HISTORIC AND DESIGN REVIEW COMMISSION

HDRC CASE NO: 2016-108

ADDRESS: 1024 S ALAMO ST

TYPE OF WORK: Additions and site modifications

A-1.00

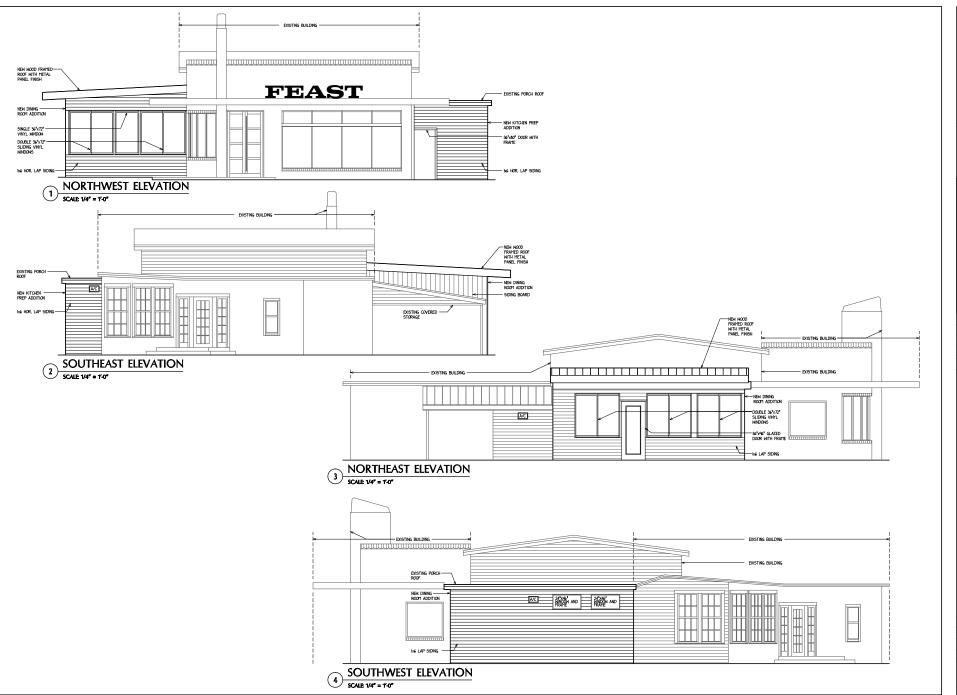
- c. The applicant has proposed materials that are to include horizontal lap siding, vinyl windows, a standing seam metal roof and doors featuring a composite material. The applicant's proposed materials of lap siding and a standing seam metal roof are appropriate, however, staff finds that aluminum windows and doors or those constructed of a metal material would be more appropriate than the proposed vinyl windows and doors.

- d. Architecturally, the applicant has proposed for the addition as well as the side enclosure to feature architectural elements that are complimentary and subordinate those of the existing structures. These elements include like materials and similarly proportioned façade elements. This is consistent with the Guidelines.

- i. That the applicant install aluminum or metal windows into the side addition to match those of the primary addition constructed circa 1950.
- ii. That the applicant install additional landscaping plant materials throughout the site. These plants should be native to South Texas.
